Our ref: DC/2021/122149/CS-01/SB5
Your ref: Second Regulation 19 consultation

**Re: Emerging East Devon Local Plan 2020-2040
Second consultation of Regulation 19 Publication Draft Nov 2025 – Jan 2026**

We are pleased to see the submission of the Water Cycle Study (WCS) (Ref.: -HAS-XX-ZZ-RP-Z-0001 dated 18th November 2025 by Haskoning). However, given the timing of the submission, we are not confident that the findings of the report have been sufficiently embedded into the plan draft.

Figure 1. – Figure 4.1 in the WCS

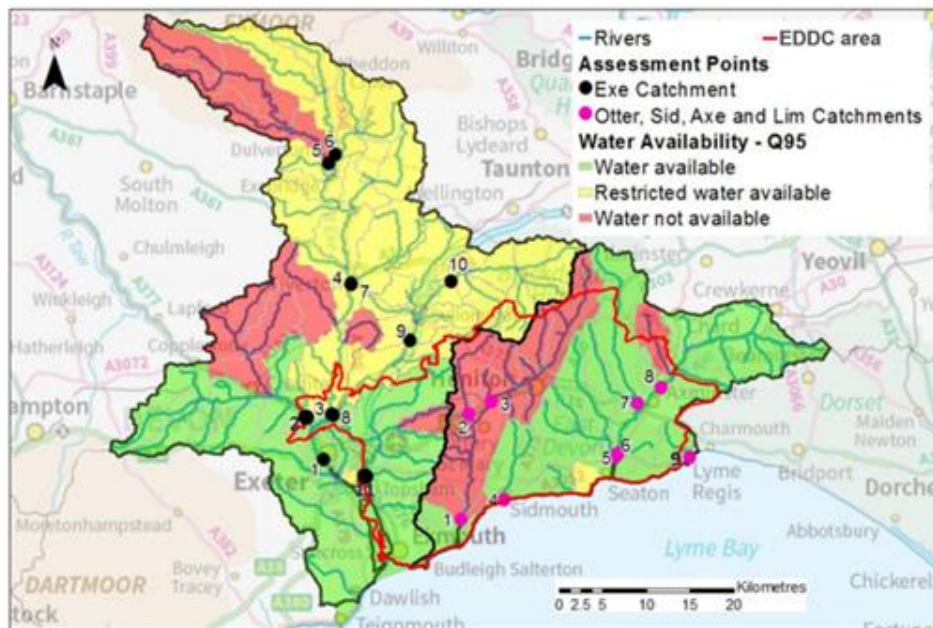
The map below is also incorrect. Paragraph 4.1 states that the SWW Wimbleball WRZ boundary is the black line on the map below (figure 4.1 in the WCS). However, the area around Starcross and Dawlish is within the Roadford WRZ. A map showing the correct boundary would be available from SWW. The WCS is correct in saying that East Devon is within Wimbleball WRZ, so this is not a material change required to the report, merely a correction of background information.
